Project	IEEE 802.16 Broadband Wireless Access Working Group <http://ieee802.org/16>	
Title	Multiple Broadcast Maps for OFDMA PHY	
Date Submitted	2004-11-04	
Source(s)	Ran Yaniv, Tal Kaitz, Vladimir Yanover, Naftali Chayat Alvarion Ltd.	ran.yaniv@alvarion.com tal.kaitz@alvarion.com
Yuval Lomnitz Intel		yuval.lomnitz@intel.com
Dave Pechner, Todd Chauvin, Doug C. Dahlby Arraycomm		dpechner@arraycomm.com chauvin@arraycomm.com dahlby@arraycomm.com
Re:	Call for contributions, IEEE P802.16e/D5 Sponsor Ballot	
Abstract		
Purpose		
Notice	This document has been prepared to assist IEEE 802.16. It is offered as a basis for discussion and is not binding on the contributing individual(s) or organization(s). The material in this document is subject to change in form and content after further study. The contributor(s) reserve(s) the right to add, amend or withdraw material contained herein.	
Release	The contributor grants a free, irrevocable license to the IEEE to incorporate material contained in this contribution, and any modifications thereof, in the creation of an IEEE Standards publication; to copyright in the IEEE's name any IEEE Standards publication even though it may include portions of

Figure 229a – Illustration of DL sub-frame structure with multiple broadcast maps

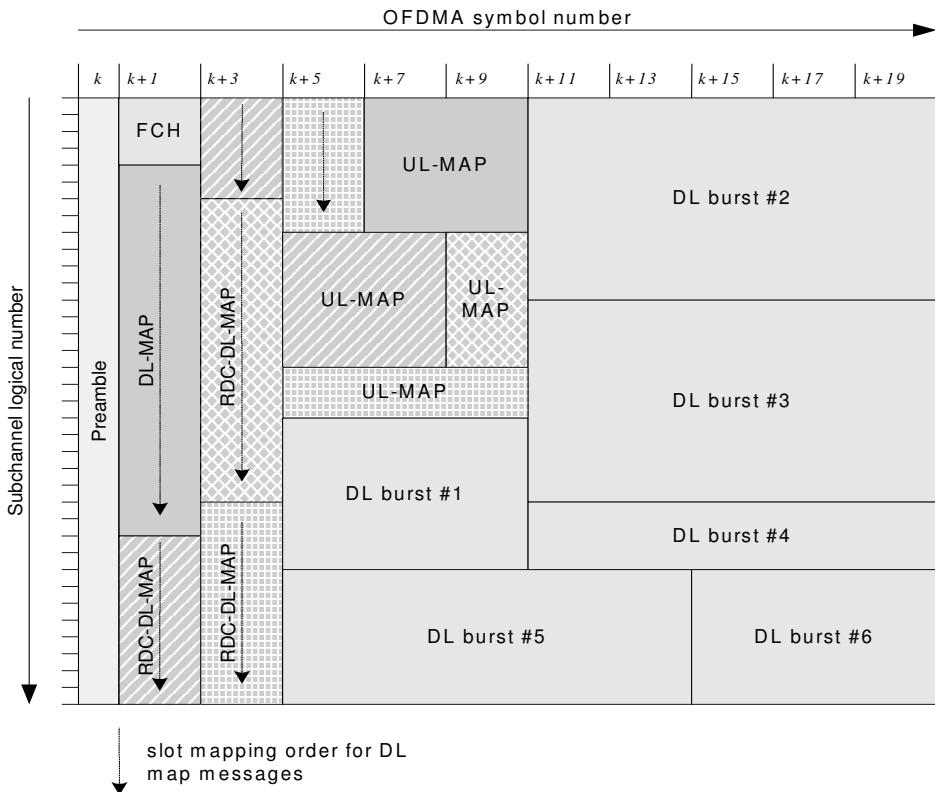
The BS may allocate dedicated PHY bursts, each containing a single RDC-DL-MAP message, for transmitting additional DL-MAP IEs with different burst profiles to SSs that support multiple broadcast maps. Such bursts, if exist, shall be allocated consecutively using the same uni-dimensional frequency-first slot mapping order used for the DL-MAP burst. The first burst containing an RDC-DL-MAP message shall be allocated starting at the slot immediately following the DL-MAP. Each RDC-DL-MAP message may also describe an UL-MAP message. Each of these UL-MAP messages shall be processed independently. UL-MAP messages shall be numbered consecutively starting from 1, in the same order in which the referencing DL-MAP/RDC-DL-MAP messages appear in the frame.

Bursts containing RDC-DL-MAP messages shall be only described by a DL-MAP-UNI IE. The DL-MAP and RDC-DL-MAP messages may contain a single DL-MAP-UNI IE that describes the next PHY burst containing the RDC-DL-MAP message. This IE (if exists) shall appear first in the DL-MAP or RDC-DL-MAP message. Each DL-MAP or RDC-DL-MAP may contain at most one DL-MAP-UNI IE.

[An SS supporting multiple broadcast maps shall attempt to decode all PHY bursts containing RDC-DL-MAP messages.](#)

[The number of RDC-DL-MAPS in a frame shall not exceed 3. The structure of the DL sub-frame with multiple broadcast maps is illustrated in figure 229a.](#)
